Item Name: Pilot/Co-pilot Shoulder Harness, 4 point

# **DART SERVICE INSTRUCTION**

TO AMEND IIN-D412-702-3 REV. A OR EARLIER

THE PURPOSE OF THIS DSI IS TO CORRECT THE HARDWARE CALLED OUT IN THE D412-702-071 KIT.

FIGURE 2. - DART D412-702-071 LAP BELT INSTALLATION (REF: IIN-D412-702)

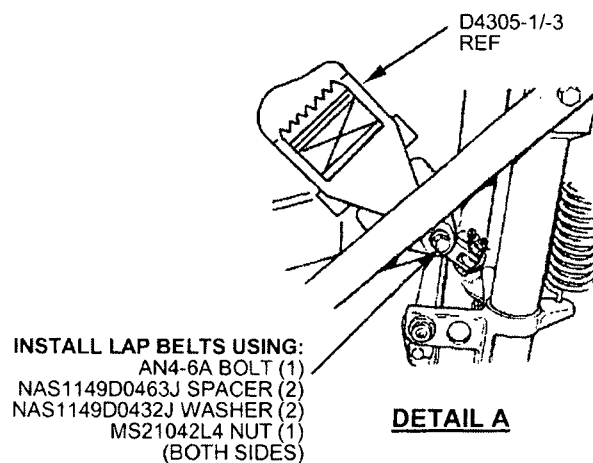
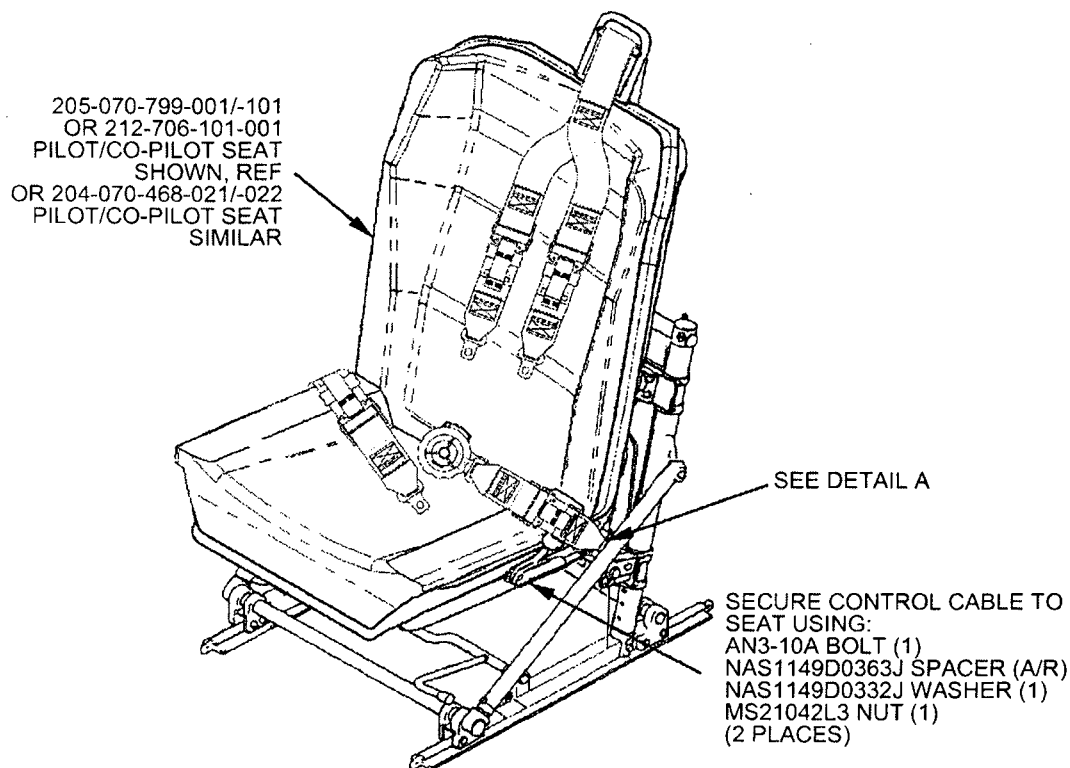
QTY -071	P/N	DESCRIPTION
X	D412-702-071	DART PILOT/CO-PILOT SHOULDER HARNESS KIT
1	D4305-041	SHOULDER HARNESS
4	AN3-4A	BOLT
2	AN3-6A	BOLT
2	AN3-7A	BOLT
14	NAS1149D0332J	WASHER
8	NAS1149D0363J	WASHER
8	MS21042L3	NUT

QTY -071	P/N	DESCRIPTION
X	D412-702-071	DART PILOT/CO-PILOT SHOULDER HARNESS KIT
1	D4305-041	SHOULDER HARNESS
4	AN3-4A	BOLT
2	AN4-6A	BOLT
2	AN3-10A	BOLT
6	MS21042L3	NUT
2	MS21042L4	NUT
10	NAS1149D0332J	WASHER
6	NAS1149D0363J	WASHER
4	NAS1149D0432J	WASHER
4	NAS1149D0463J	WASHER
